# HISTORIC AND DESIGN REVIEW COMMISSION

October 06, 2021

**HDRC CASE NO:** 2021-472  
**ADDRESS:** 114 PARKVIEW DR  
**LEGAL DESCRIPTION:** NCB 6919 BLK LOT E 20 FT OF 12 & W 15 FT OF 13  
**ZONING:** R-5, H  
**CITY COUNCIL DIST.:** 3  
**DISTRICT:** Mission Historic District  
**APPLICANT:** HMI Homes, LLC  
**OWNER:** HMI Homes, LLC  
**TYPE OF WORK:** Fenestration modifications, siding modifications  
**APPLICATION RECEIVED:** September 09, 2021  
**60-DAY REVIEW:** Not applicable due to City Council Emergency Orders  
**CASE MANAGER:** Katie Totman

An example of the proposed new porch cover.

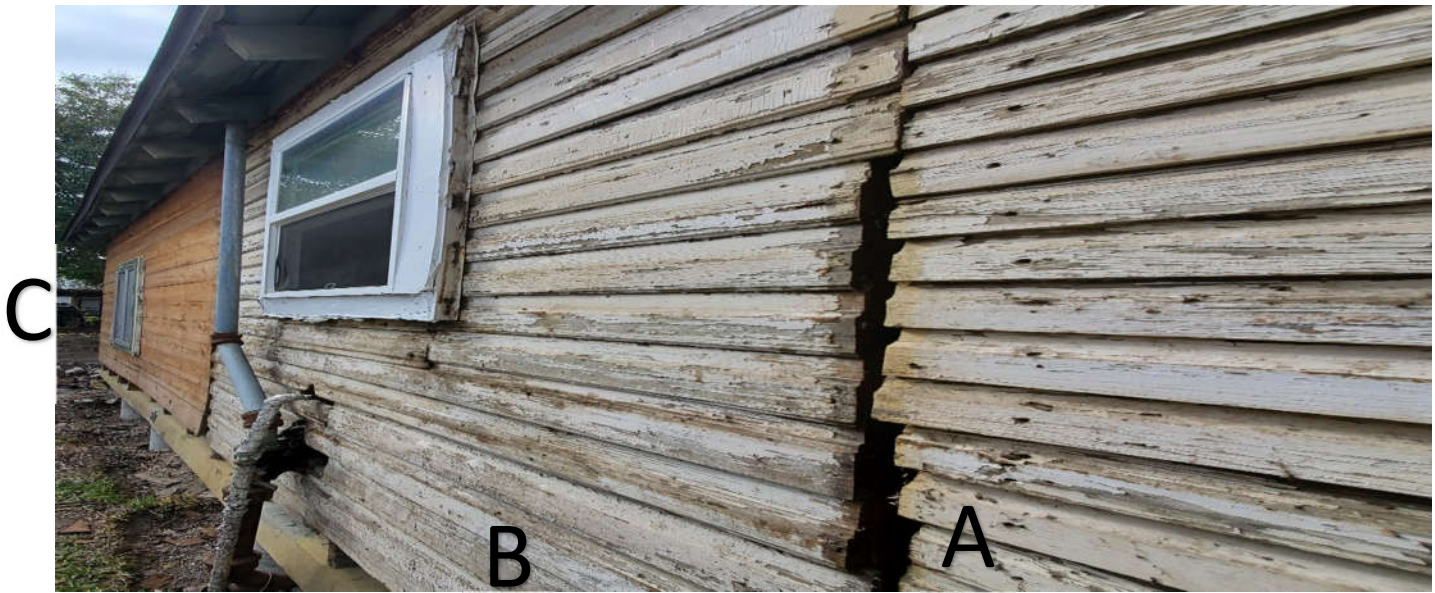
- f. **FRONT PORCH MODIFICATIONS** – The applicant is requesting to remove the existing metal awning and construct an offset front gable porch cover with wood posts. Per the Historic Design Guidelines for Exterior Maintenance and Alterations 7.B.v., reconstruct porches, balconies, and porte-cocheres based on accurate evidence of the original, such as photographs. If no such evidence exists, the design should be based on the architectural style of the building and historic patterns. Many of the adjacent homes with similar architectural

features exhibit an offset front gable porch cover. Staff finds that the introduction of this element is an appropriate treatment.

- i. That the existing historic wood siding be removed and replaced with 4” Dutch lap wood siding versus being covered by new siding.
- ii. That the applicant provide staff with product specifications of the proposed wood window prior to the issuance of the COA.
- iii. That the proposed front door be wood to be consistent with the design guidelines.
- iv. That the front porch columns be no thicker than 6” square, feature chamfered corners and top and bottom trim.

**Image of replacement front door**

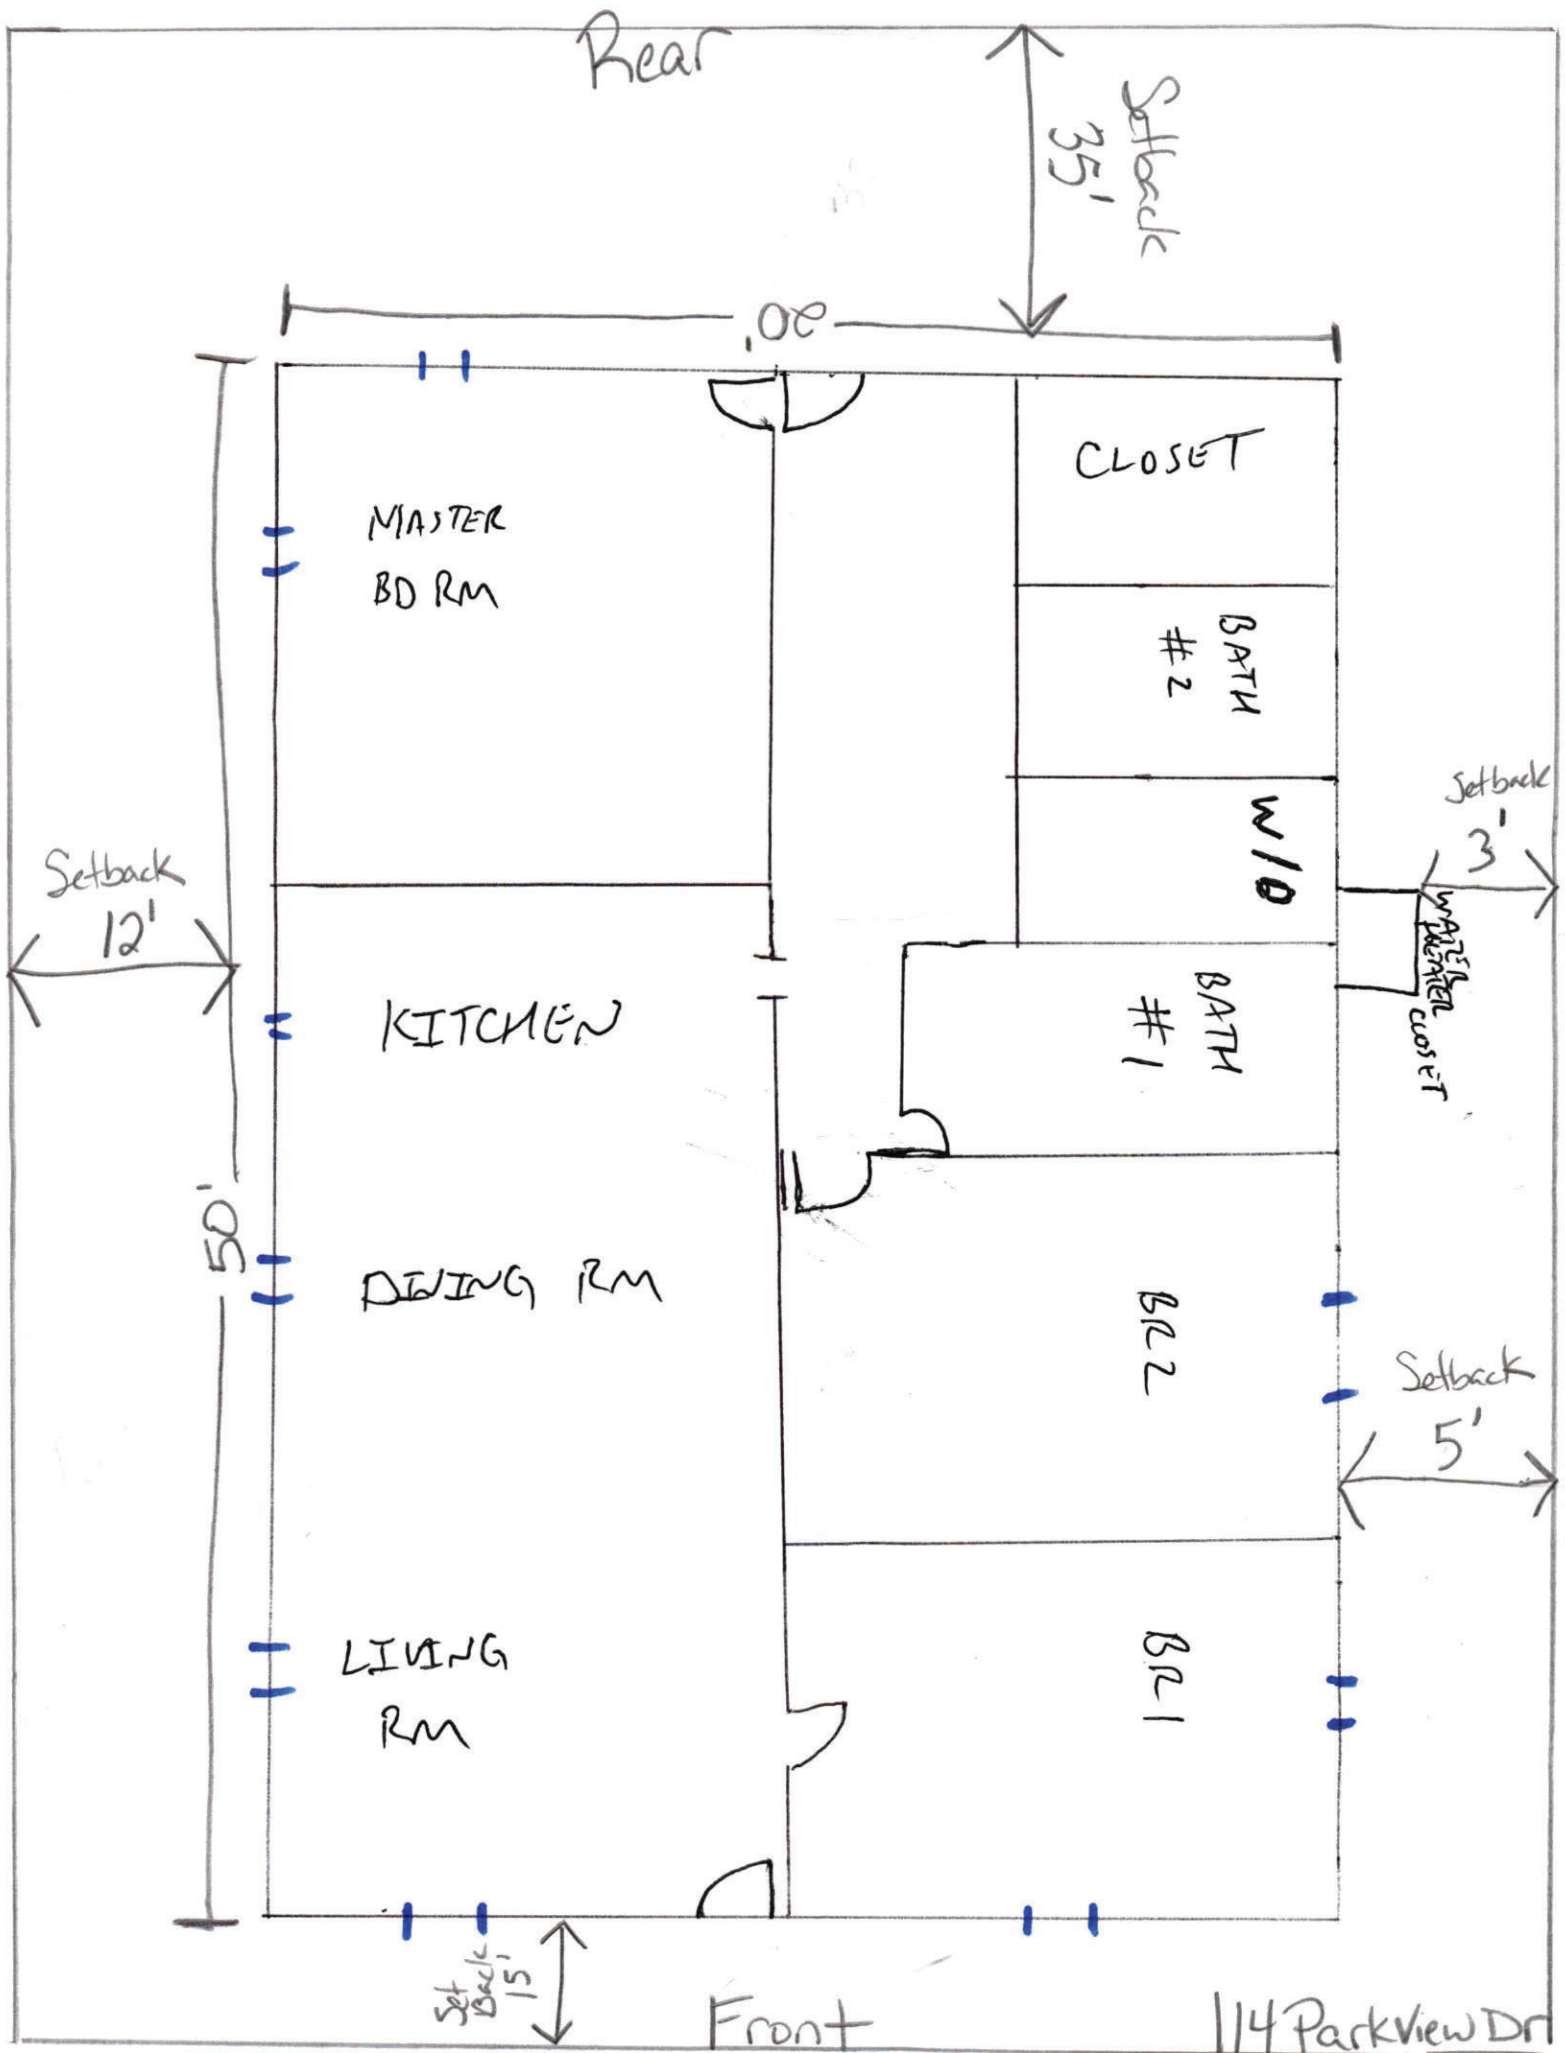
- e. **FRONT DOOR REPLACEMENT** – The applicant is requesting to replace the existing front door with a 36” x 80” fiberglass Craftsman door. The existing door is likely not original to the structure as it is a contemporary material and appearance. Per the Historic Design Guidelines for Exterior Maintenance and Alterations 6.B.i, Replace doors, hardware, fanlight, sidelights, pilasters, and entablatures in-kind when possible and when deteriorated beyond repair. When in-kind replacement is not feasible, ensure features match the size, material, and profile of the historic element. Staff finds that the proposed style of the door to be consistent with the Craftsman features of the primary structure and finds that the door should be solid wood or a salvaged wood door where possible.
